RE: Black Butte Mining Operation Application

I have reviewed the following sections of the Black Butte Copper Project Mine Operating Permit Application (“Application”) on geochemistry and water treatment plans: Chapters 1.1, 1.2, 1.4, 2.4, 3.5.4, 3.7.3, 4.2, 6.3.2, 6.3.3, and Appendices C and D.

Figure 1. Potential acid generation of major waste rock lithologies. Figure 2-10 of the 2015 Black Butte Mining Operation Application.

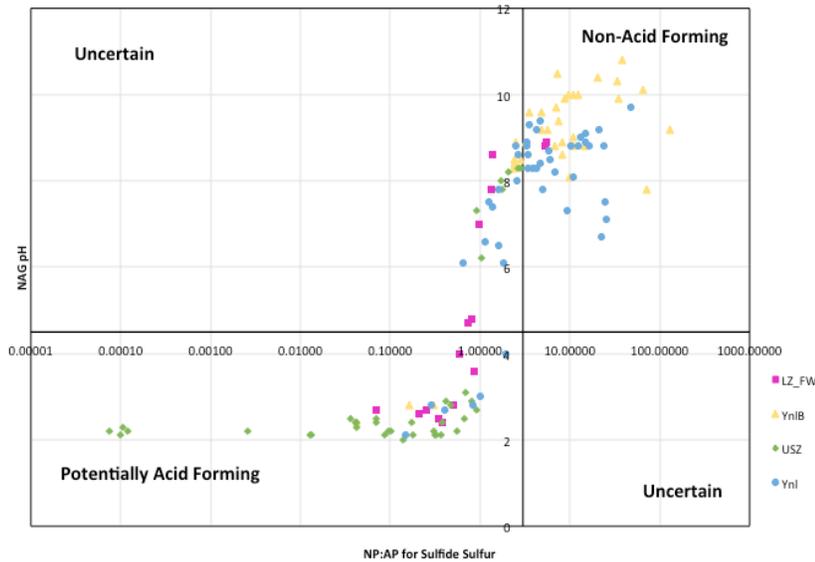
Relative to the 2013 PEA, a revised operation plan indicates that there will be significantly less of the Ynl lithology (now 4% of waste rock, rather than the 41%) and more with high potential acid generation (lithology USZ (Upper Sulfide Zone) will be 28% of the waste rock rather than the 11% previously estimated).

The USZ, Lower Zone Footwall (LZ-FW) and Ynlb lithologies will make up approximately 1/3 of waste rock each, with potential acid generation from both USZ and LZ-FW. Material from Ynl may be used as construction rock, and also has potential for acid generation – and therefore metal leaching.
